SUBJECT: DIFFERING PROFESSIONAL OPINION INVOLVING  
DIABLO CANYON SEISMIC ISSUES  
(DPO-2013-002)

The DPO (Enclosure 1) raises concerns about a 2011 Pacific Gas and Electric (PG&E) report to the NRC that included a reevaluation of the local geology surrounding the Diablo Canyon Power Plant. In particular, the DPO focuses on whether adequate action was taken to address the new seismic information into the current licensing basis and whether appropriate actions were taken to address operability.

Figure 1. Increased Predicted Ground Motions from Near Plant Earthquake Faults

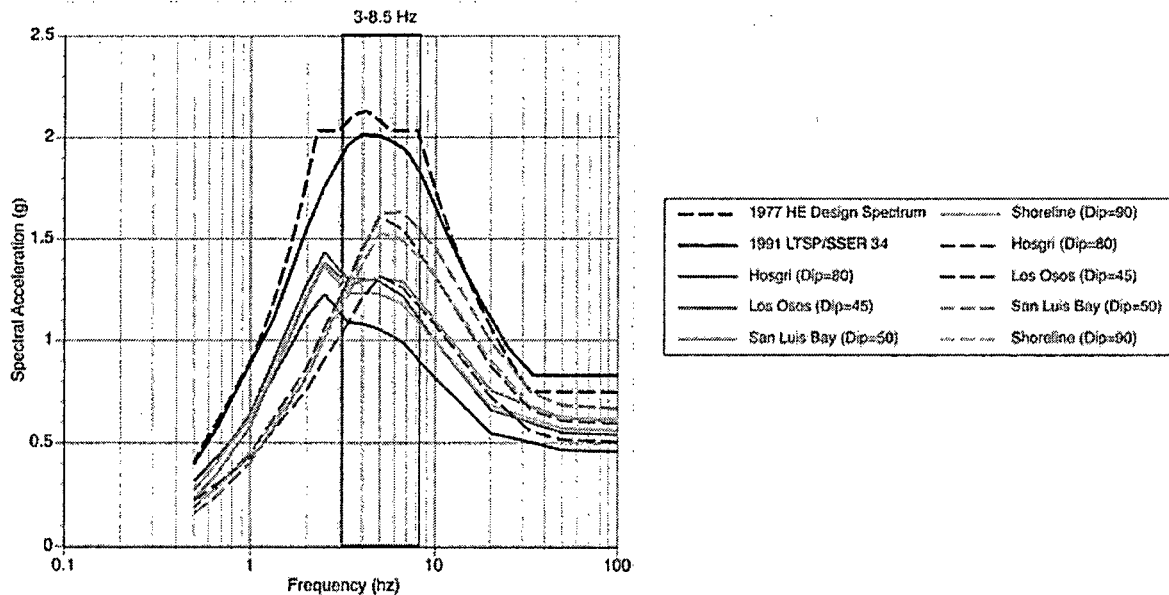
Diablo Canyon SSCs may not be able to perform their specified safety functions following a Safe Shutdown Earthquake. Figure 1 shows the increase in predicted ground motions at the site from an reevaluation of three near plant earthquake faults. New seismic studies established that ground motions from the Los Osos, San Luis Bay, and Shoreline Faults now exceed the ground motions of the Safe Shutdown Earthquake (not shown on the graph). Table 1 compares the peak ground acceleration from each fault (at 5% damping)<sup>1</sup> with the OBE and SSE peak ground motions (0.2 g and 0.4 g).<sup>2</sup> PG&E has not evaluated the increase in seismic ground motion against the SSC qualification basis for the OBE and SSE. The previous NRC replacement reactor head inspection concluded very little seismic margin exists for some RCS pressure boundary ASME Section III Boiler and Pressure Vessel Code limits.<sup>3</sup> The increases in OBE and SSE seismic loading from the new information would likely result, if evaluated, in ASME Code allowable limits being exceeded; rendering some RCS pressure boundary components inoperable.

Figure 2. Horizontal Design Response Spectra – Scaled to 1g Horizontal Ground Acceleration

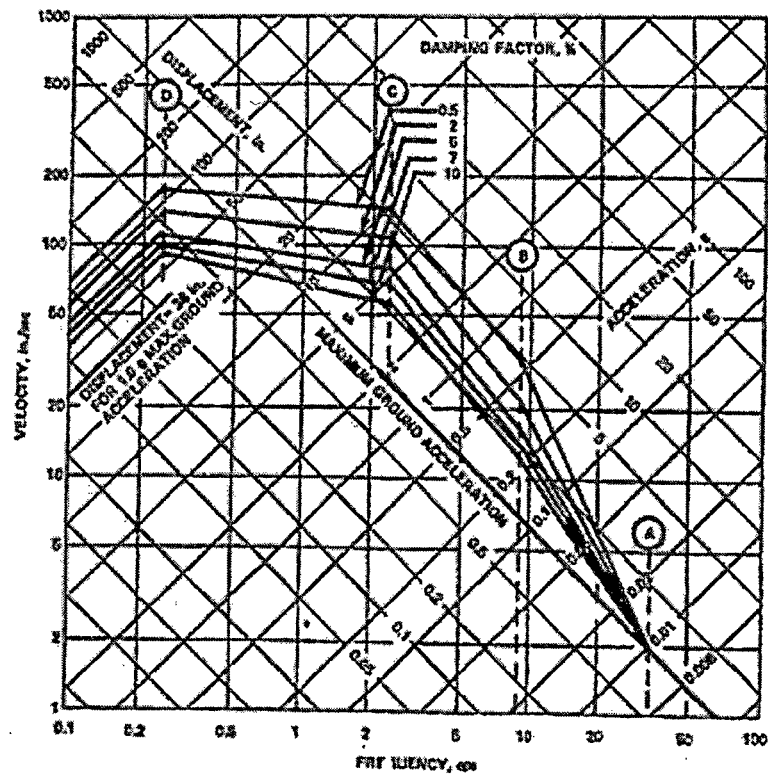
Figure 2 illustrates the affect that damping has on component amplification and displacement velocity for an earthquake normalized with a 1.0 g peak horizontal ground acceleration (Point A).<sup>14</sup> For the natural frequency range for most seismically qualified SSC (3.3 – 8 Hz, between Points B & C), velocity and acceleration can vary greatly with damping. For example, the figure shows that a component with a natural frequency of 3.3 Hz, using a damping value of 0.5% results in a velocity of approximately 125 in/sec, while using a damping value of 10% results in a velocity of only about 55 in/sec. Figure 3 illustrates how changes in assumed damping directly affect acceleration at the auxiliary building floor for the Hosgri Event. The figure shows that applying a larger damping value results in a much lower acceleration.

Figure 5  
SSE Maximum CRDM Bending Moments

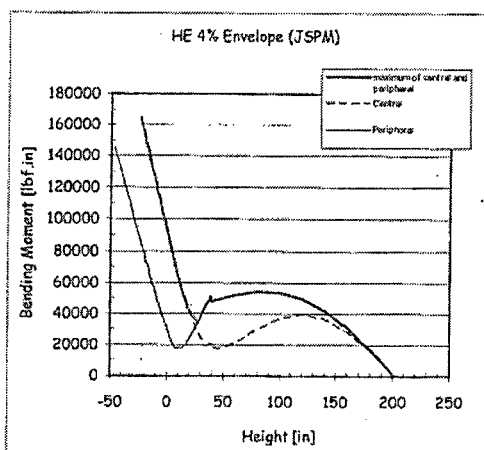
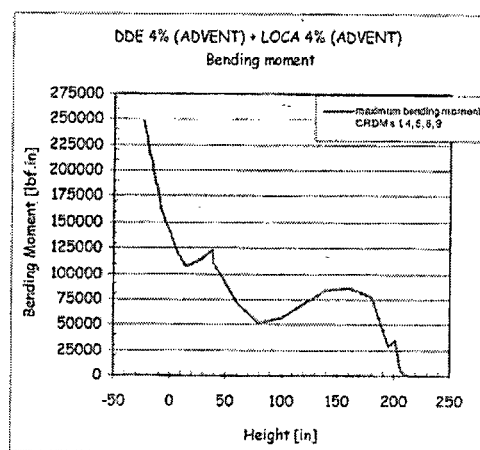
Seismic qualification of the primary RCS pressure boundary was limited by all three design basis earthquakes. For some SSC, the HE was more limiting, for others, the SSE or OBE was more limiting for seismic qualification. For example, the inspectors identified that the OBE and SSE were more limiting for some RCS pressure boundary components during the Unit 2 replacement reactor head inspection. The replacement head designer used inappropriately high seismic damping values when demonstrating that RCS pressure boundary met Section III of the ASME Boiler and Pressure Vessel Code. For corrective action, the designer recalculated RCS component stress using the current licensing basis (CLB) damping values and discovered that some reactor head components exceeded Code allowable values for the OBE.<sup>18</sup> The designer again recalculated Code allowable stress using the higher damping values provided in RG 1.61, "Damping Values for Seismic Design of Nuclear Power Plants," Revision 1. The second recalculation also resulting in component stress levels exceeding Code allowable. The design subsequently demonstrated Code acceptance criteria by substituting the time history method with response spectrum method. Incorporating the higher RG 1.61 damp values into the CLB required a licensee amendment. The end result did not provide for much margin to accommodate an increase in the design basis earthquake. The recalculation concluded that the SSE was more limiting.<sup>19</sup> For example, as shown in Figures 4 and 5, the control rod drive mechanism pressure housing assembly (CRDM) bending moments were more limiting for the SSE than the HE.

The recalculation also identified that SSE loads were more limiting than the HE for the control rod drive mechanism pressure housing assembly and the external loads for the vessel head closure weld shear forces (6,332 lbs for the SSE compared to 4,431 lbs for the HE). Also, both the OBE and SSE inner and outer diameter shear forces were more limiting than the HE (OBE was 9,764 lbs, SSE was 6,567 lbs, while the HE was only 4,432 lbs).<sup>20</sup>
